Basalt Creek Parkway winter 2022 open house summary

The Basalt Creek Parkway online open house was active Feb. 25-March 13, 2022. During that time, 248 people visited the open house, leaving 23 comments. A summary of comments and responses is below.

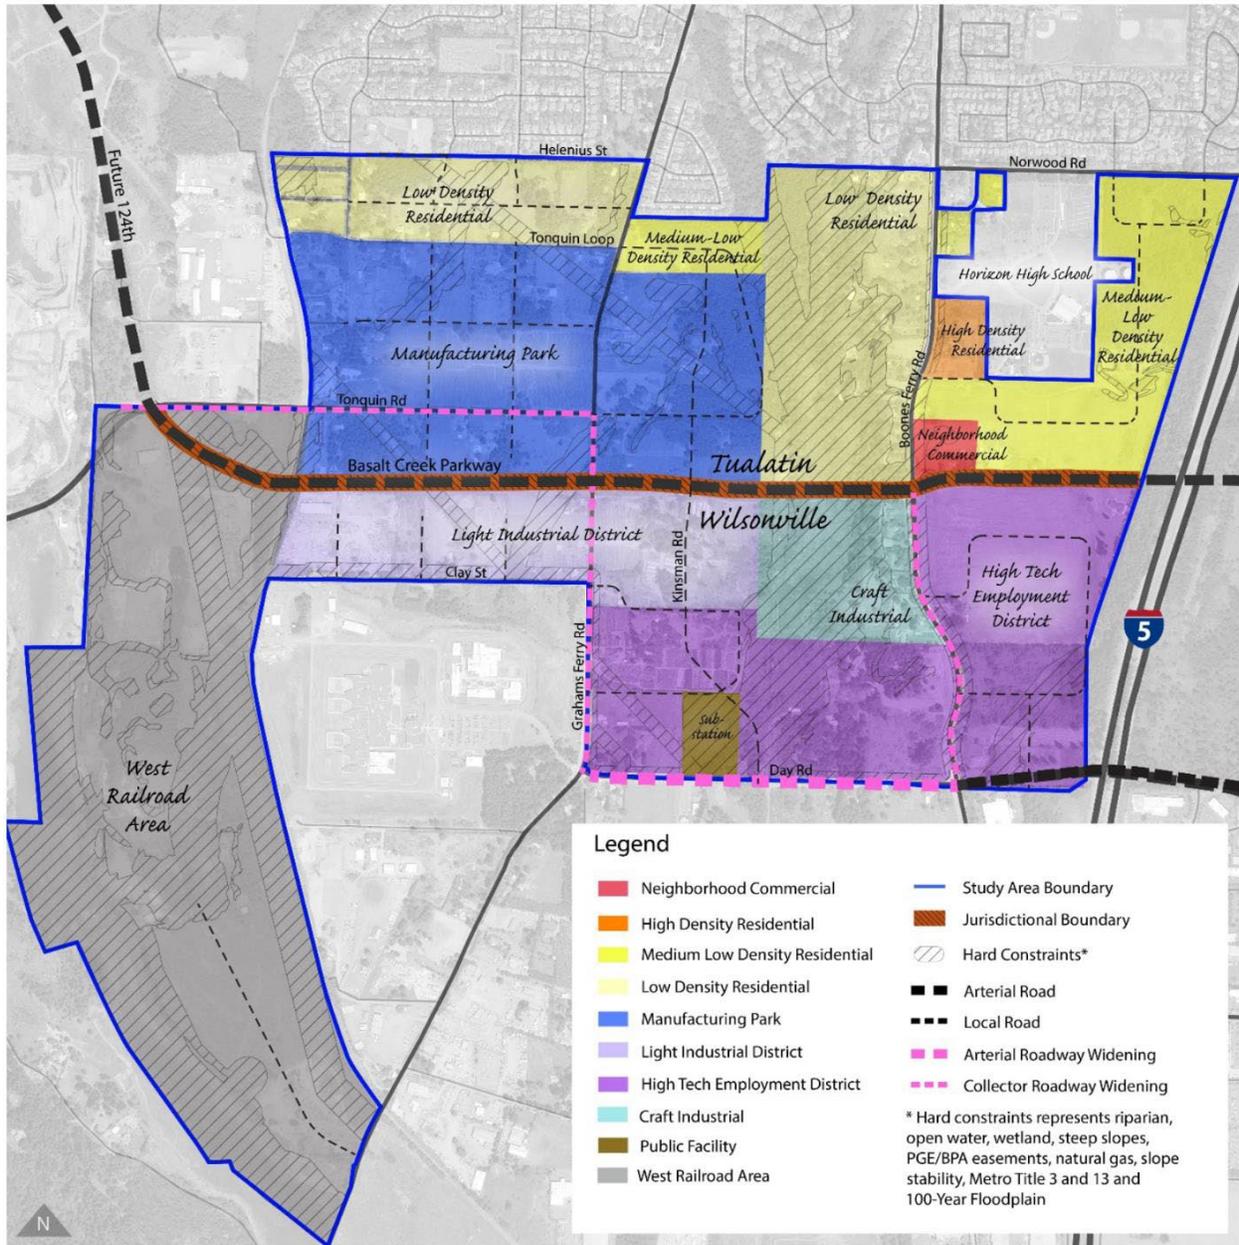
Why does the noise report not take current residential uses into account? Why is no mitigation proposed?

The noise report does take current residential uses into account. Thirty residential properties were analyzed in the noise report.

Sound walls are considered reasonable if the cost per benefitted property owner is less than \$25,000 according to Oregon Department of Transportation (ODOT) guidelines. The cost per property impacted by this project significantly exceeds that amount. On the north side of the street, it would cost \$267,000 per property owner. On the south side of the street, it would cost \$114,000 per property owner.

Sounds walls are not proposed as stated in the open house information and [noise report](#).
